SERVICE BULLETIN

NO. 200-004 DATE 57-10-8 (SUPERSEDES NO.)
REV. DATE (SUPERSEDES NO.)
REASON

1. SUBJECT : Engine Driven Fuel Pump Outlet Tee, Inspection and Replacement of
2. AIRCRAFT AFFECTED : All FA200-180 aircraft S/N 12 and sub (excluding-180AO)

Figure 1. Installation of Engine Driven Fuel Pump

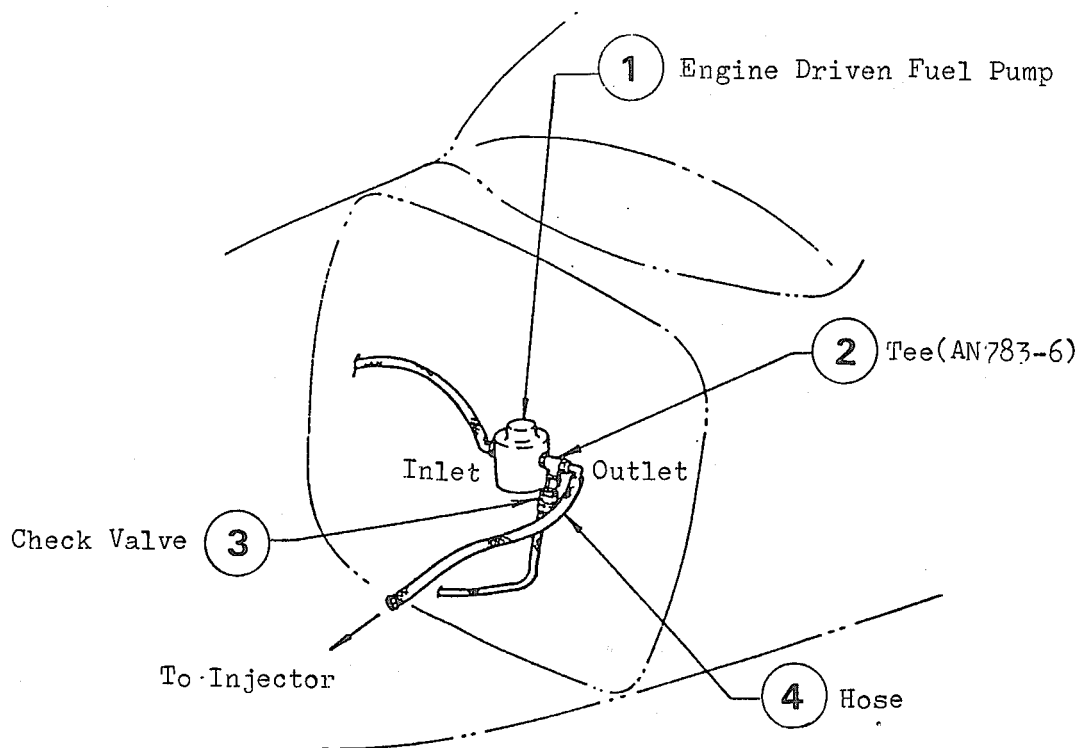
B. Perform dye penetrant inspection and replace tee as follows: (See figure 1)

- 1) Open upper cowlings. Remove upper cowling (if FRP cowling is installed).
- 2) Loosen nut connecting engine driven fuel pump (1, figure 1) and AN783-6 tee (2).
- 3) Loosen nut connecting check valve (3) and tee (2).
- 4) Loosen nut connecting tee (2) and hose (4), and remove hose (4).
- 5) When tee (2) is replaced, always install new serviceable part. Discard the removed tee.
- 6) When dye penetrant inspection is performed, inspect tee (2) for cracks as shown in the figure 2. If crack is found, replace tee with new serviceable item.
- 7) Reverse the preceding steps 4) through 1), and reinstall loosened or removed parts with new "O" rings.
- 8) Bleed trapped air from the system, and then perform leak check in accordance with para 12. A described above.

Figure 2. Inspection of Tee (AN783-6)

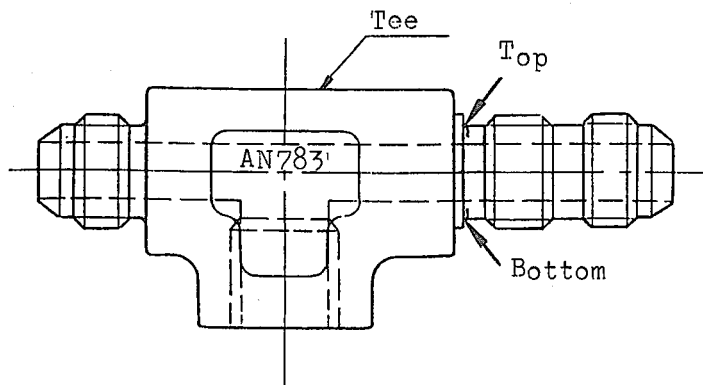
5. DESCRIPTION : (1) Leak Check :
- With mixture lever in "Cut-Off" position, turn auxiliary fuel pump "ON", and check engine driven fuel pump outlet tee for fuel leakage at the position as shown in the attached figure 2. If fuel leakage is found, replace the tee (AN783-6) with new serviceable item.

- (2) Dye Penetrant Check :
- Remove engine driven fuel pump outlet tee, and, using a dye penetrant inspection method, ensure no cracks exist in the location as shown in the figure 2. If crack is found, replace the tee (AN783-6) with new serviceable item.

Inspect tee for crack or leakage around area indicated by arrows, paying particular attention to top and bottom.
